**UNITED STATES
NUCLEAR REGULATORY COMMISSION
REGION IV
611 RYAN PLAZA DRIVE, SUITE 400
ARLINGTON, TEXAS 76011-4005**

**SUBJECT: SOUTH TEXAS PROJECT ELECTRIC GENERATING STATION - NRC SPECIAL
INSPECTION TEAM REPORT 05000498/2003008 AND 05000499/2003008 AND
EXERCISE OF ENFORCEMENT DISCRETION**

Report No: 05000498/2003008
05000499/2003008

Facility: South Texas Project Electric Generating Station, Units 1 and 2

Figure 2

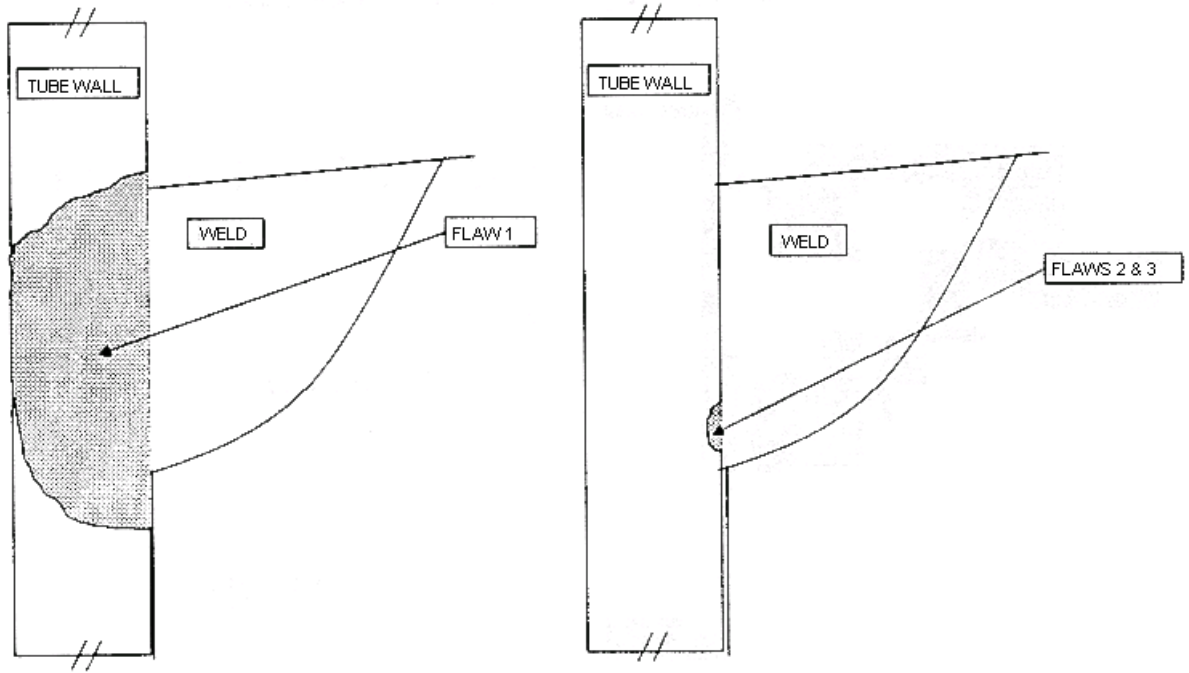
The results from BMI Penetration 1 are depicted in Figure 2. Three axially-oriented crack-like indications were identified in the nozzle wall. One of the indications was characterized as an axial crack with a length of about 1.38 inches, surface breaking on the OD of the nozzle above and below the J-groove weld, as well as surface breaking on the ID of the nozzle. The ID surface breaking nature of this flaw was confirmed by the ET examination. The OD surface breaking nature of this flaw was confirmed by the helium gas test. The other two indications were characterized as being small, embedded (i.e., non-surface breaking) cracks near the interface between the nozzle wall and the root pass of the J-groove weld.

Figure 3

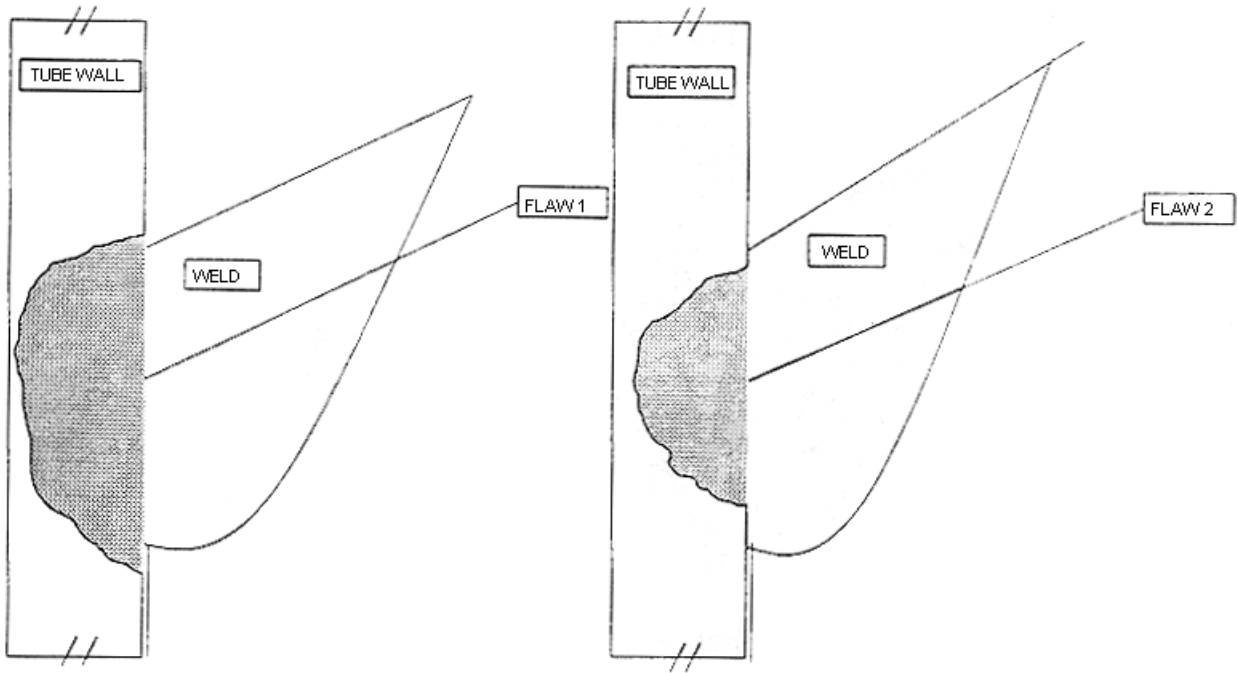
The results from BMI Penetration 46 are depicted in Figure 3. Two axially-oriented crack-like indications were identified in the nozzle wall. One of the indications was characterized as an axial crack with a length of about 0.98 inches, surface breaking on the OD of the nozzle above and below the J-groove weld. The surface breaking nature of this flaw was unable to be confirmed by the helium gas test. The flaw was not found to be surface breaking on the ID of the nozzle by the ET examination. The other indication was characterized as an embedded crack having an axial length of 0.95 inches.

Figure 4

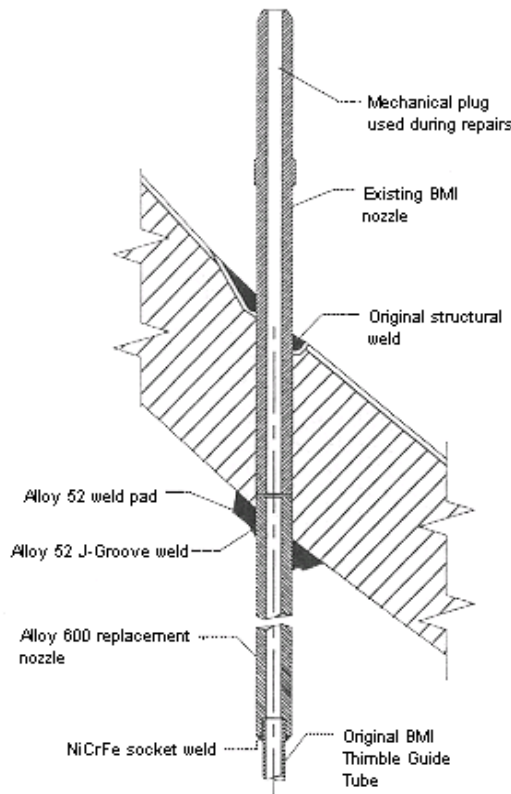
The team reviewed the licensee’s prompt corrective actions in response to the BMI leakage issue. The team reviewed the modification package which installed the BMI penetration repair and observed portions of its installation and inspection on BMI

Upon the discovery of the deposits around STP, Unit 1, BMI Penetrations 1 and 46, the licensee began the process of designing a potential repair option. The licensee developed a “half-nozzle” repair which was similar in design to those which had been implemented at other facilities for the repair of cracked pressurizer heater penetrations, RCS instrumentation penetrations, etc. This repair option was chosen and characterized as a permanent repair of STP, Unit 1, BMI Penetrations 1 and 46. A cross-section of the repair design is shown in Figure 4. The essential elements of the repair design were as follows:
